**Application Number:** 22PLN-37  
**Subject:** Development Review Permit for the construction of a three-story, ±42,000 square foot/80 room Holiday Inn Express on a 2.74 acre portion of an 11.77 acre parcel  
**Location/APN:** 961 Plaza Drive/035-480-039  
**Owner:** Rajinder Singh, Grass Valley Hospitality, Inc.  
**Applicant:** Jeff Morrish, NST Engineering, Inc.  
**Zoning/General Plan:** Central Business (C-2) Zone/Commercial  
**Entitlements:** Development Review Permit

## **Holiday Inn Express Proposed at 961 Plaza Drive**

Sheet No.  
**C6**  
 Of 6 Sheets

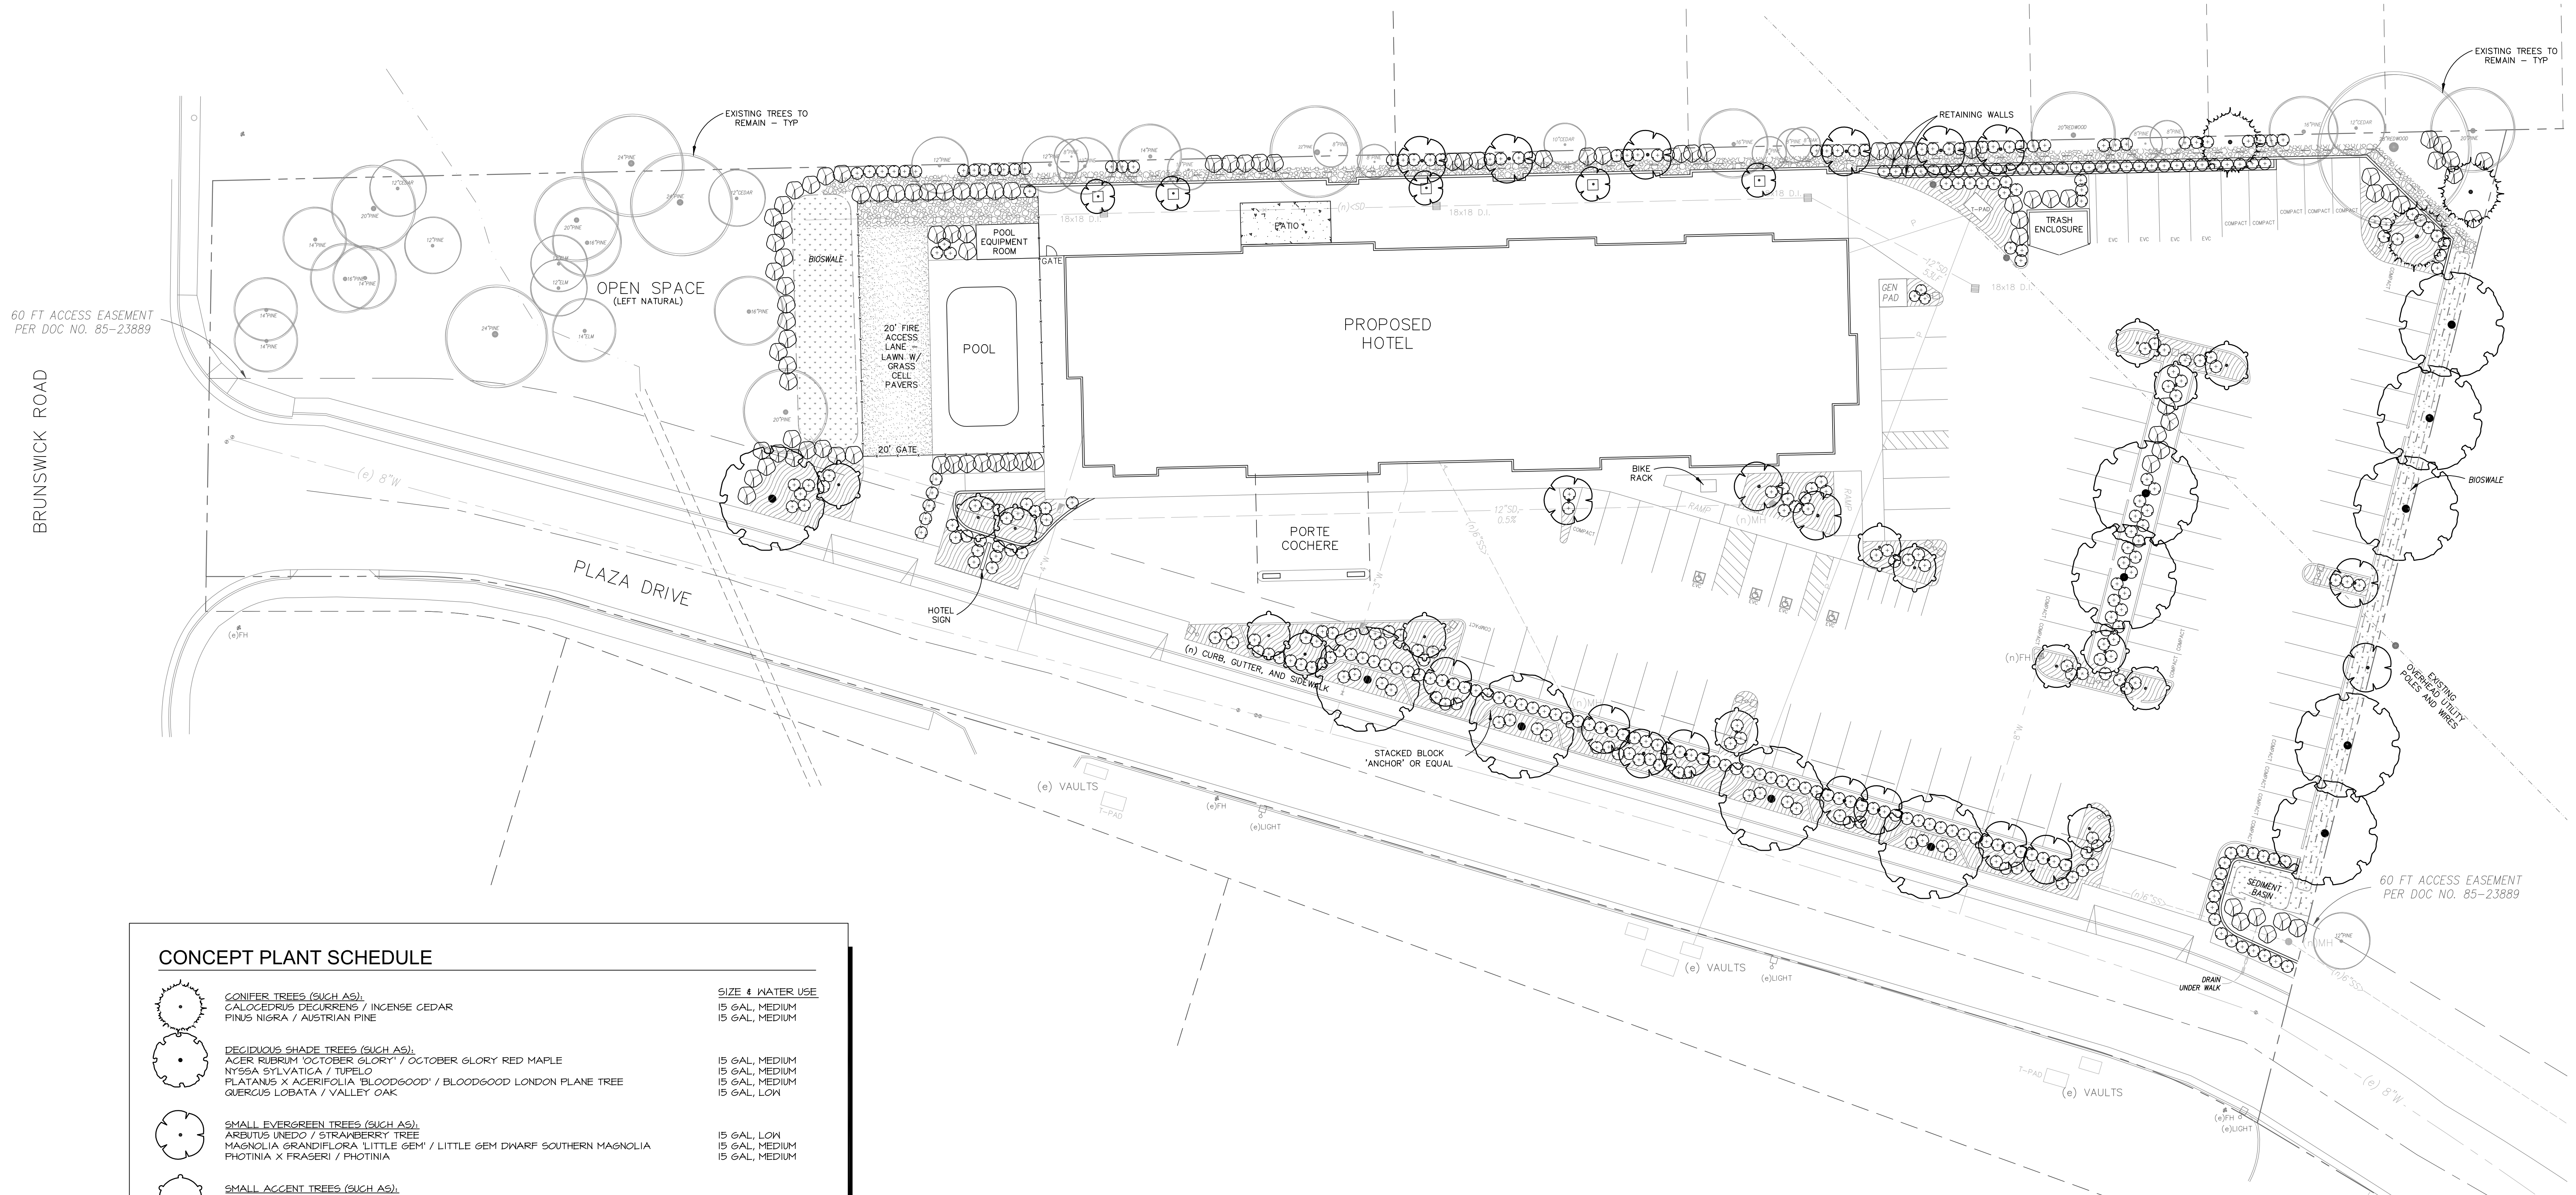
8. Sheets C3, C4, and C6 show the EV charging spaces.
9. The Geotechnical Engineering Study and Cultural Resource Inventory Survey are attached.
